**DRAFT EUROPEAN CONNECTION CONDITIONS LEGAL TEXT**

**DATED 13/12/17**

**EUROPEAN CONNECTION CONDITIONS  
(ECC)**

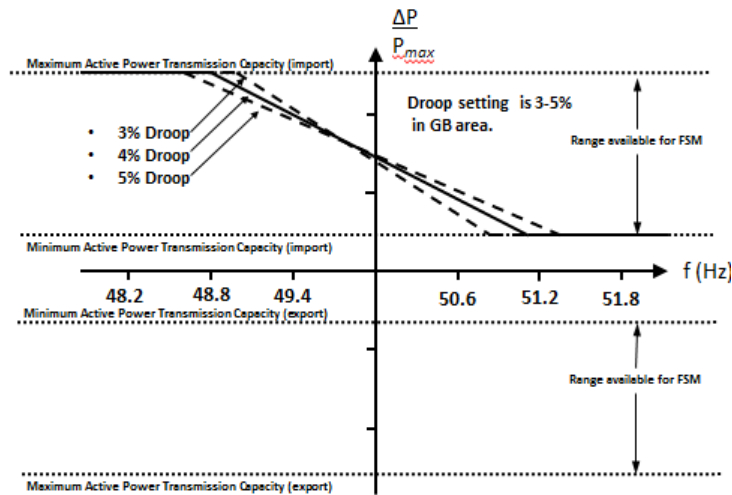
**Comment [A16]:** Diagram needs to be re-drawn - with GB parameters. There needs to be a reduction in the equations

Figure ECC.A.7.2.2b

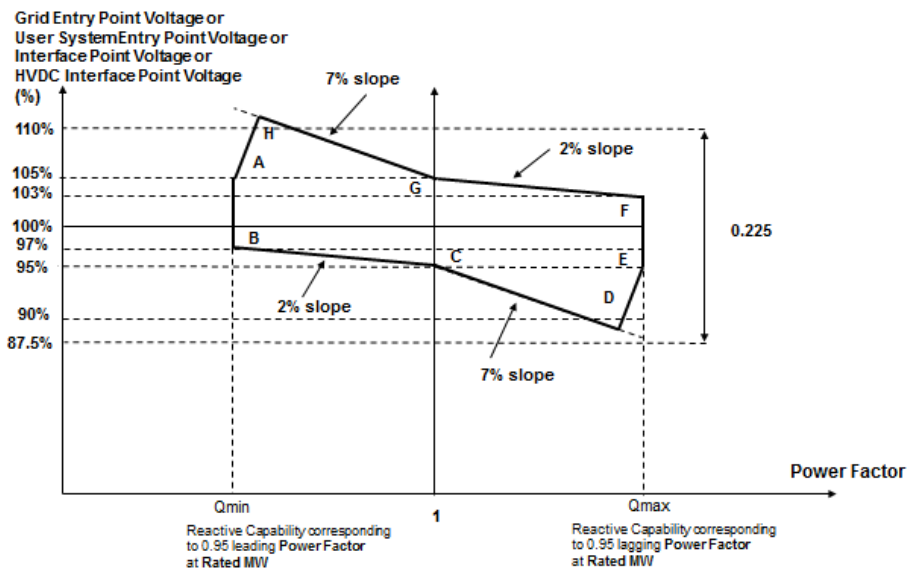
**Comment [A21]:** This diagram needs updating to include HVDC Interface Point Voltage
